GEORGIA POWER CO.
et al.

(Vogtle Electric Generating Plant,
Units 1 and 2)

AFFIDAVIT OF CARL H. BERLINGER IN SUPPORT
OF NRC STAFF RESPONSE TO APPLICANTS'
MOTION FOR SUMMARY DISPOSITION OF CONTENTION 14

SUBJECT: SAFETY EVALUATION REPORT, TRANSAMERICA DELAVAL, INC.
DIESEL GENERATOR OWNERS GROUP ANALYSIS OF THE R-4 AND
RV-4 SERIES EMERGENCY DIESEL GENERATOR ENGINE AND
AUXILIARY MODULE WIRING AND TERMINATIONS

FIGURE 1. Air Start Valve Assembly

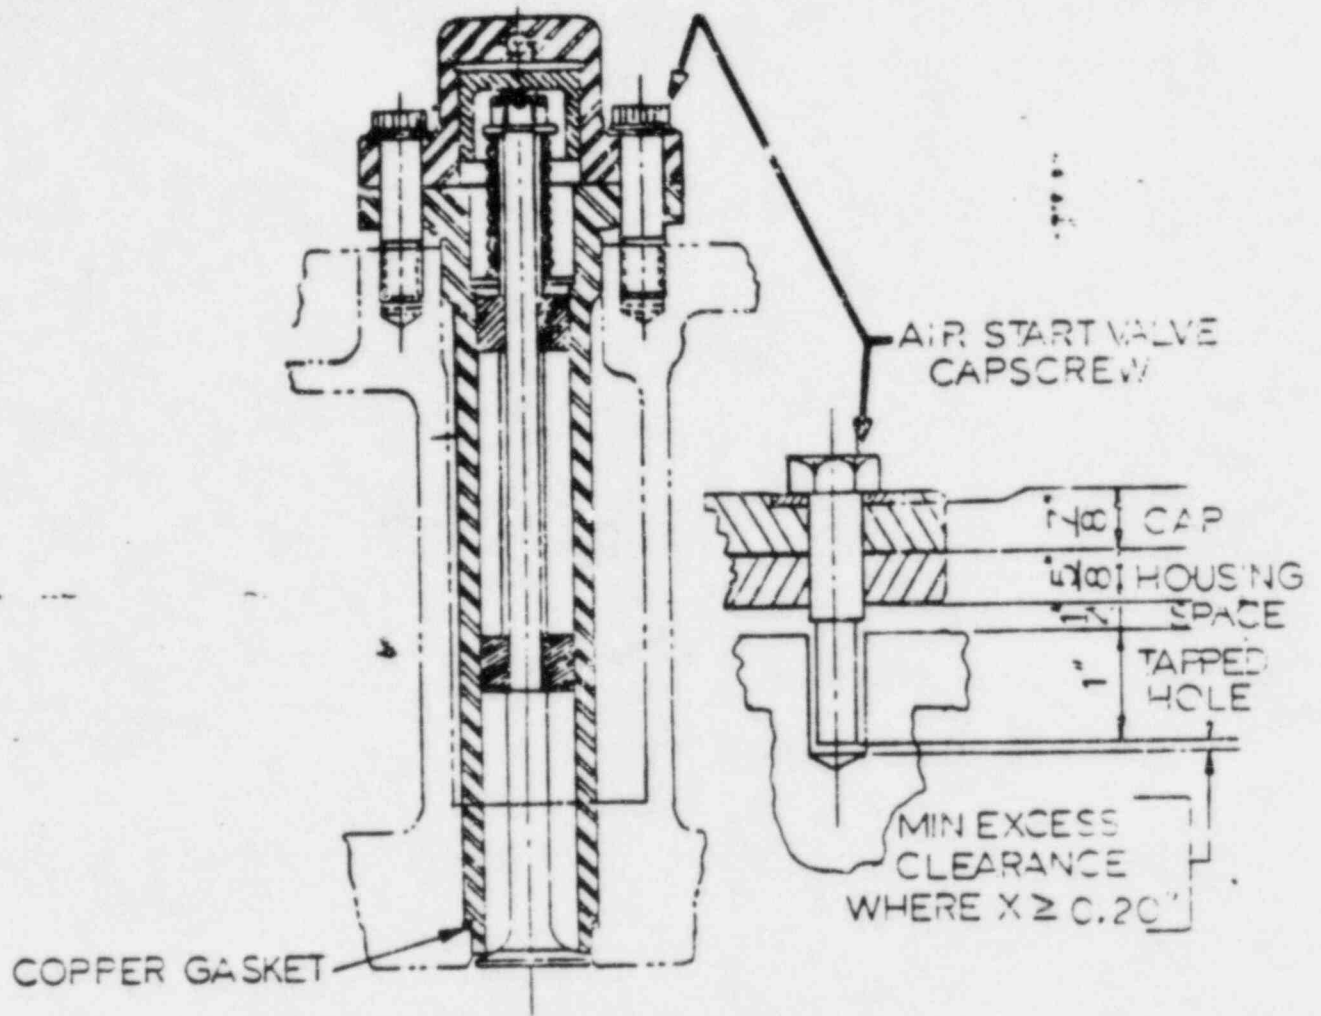
- During engine startup, a stress is imposed on the capscrews due to starting air pressure within the air start valve assembly. This stress is insignificant compared to the greater alternating stress induced by cylinder firing pressures.
- During engine operation, the valve assembly copper gasket is subjected to elevated temperatures. As a result of the temperature rise and preload, creep occurs within the gasket, which will decrease the total capscrew preload. To compensate, the existing diesel engine maintenance procedures require retorquing at specified intervals until no change is detected. At this time the gasket is fully compressed at its operating temperature by the required preload. Hence, capscrew preload is maintained during the full range of engine operation.

As a result of the initial review, the PNL reviewers requested additional information and supporting calculations (Laity April 23, 1984). Handwritten calculations (Stone & Webster calculation 245.1-M3) and additional information were received in reply (Ray June 20, 1984). The Stone & Webster report, the supplemental handwritten calculations, and written responses to PNL's questions formed the basis for the review of the Owners' Group resolution of the air start valve capscrew problem.

length be measured, on a sample basis, as a part of the DR/QR effort for each plant. Also, an installation procedure was recommended to ensure that the proper preload was imposed on the capscrews. The procedure calls for the initial installation of these capscrews with 150 ft-lb torque followed by retorquing every 8 hours until no further change is noted in the torque. PNL concurs with the procedure; however, PNL recommends that the torque on these capscrews be checked following the first period of engine operation after a new gasket is installed, to ensure that no additional gasket creep occurs as a result of the additional thermal and mechanical stresses.
